REMARKS

AMENDMENTS TO THE DRAWINGS

Fig. 7

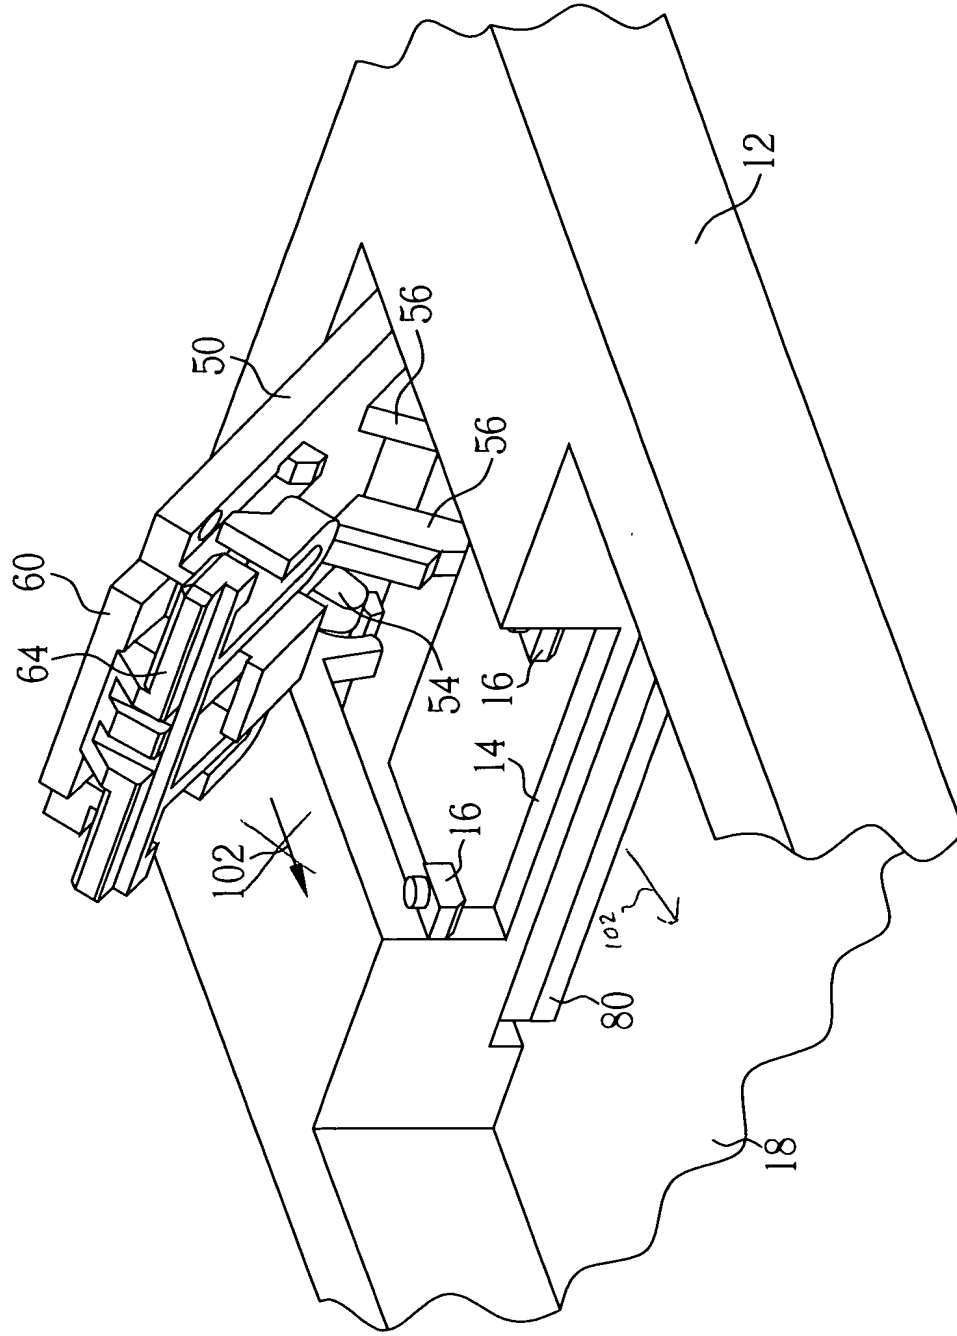
20 The drawings are objected to because: Figure 7, for card 80 an arrow like 102 should be added.

25 The arrow 102 in Fig.2 was originally intended for indicating the direction that the card 80 moves when exiting. To more clearly show this, the arrow 102 has been moved from its original position closer to the card 80. No new matter has been added. Acceptance of the amended drawing is requested.

The attached sheet of drawings includes changes to Fig.7. This sheet replaces the original sheet containing Fig.7. In Fig.7, arrow 102 has been moved closer to the card
5 80 for more clearly indicating the direction in which the card 80 will exit. No other changes have been made, and no new matter has been added to Fig.6.
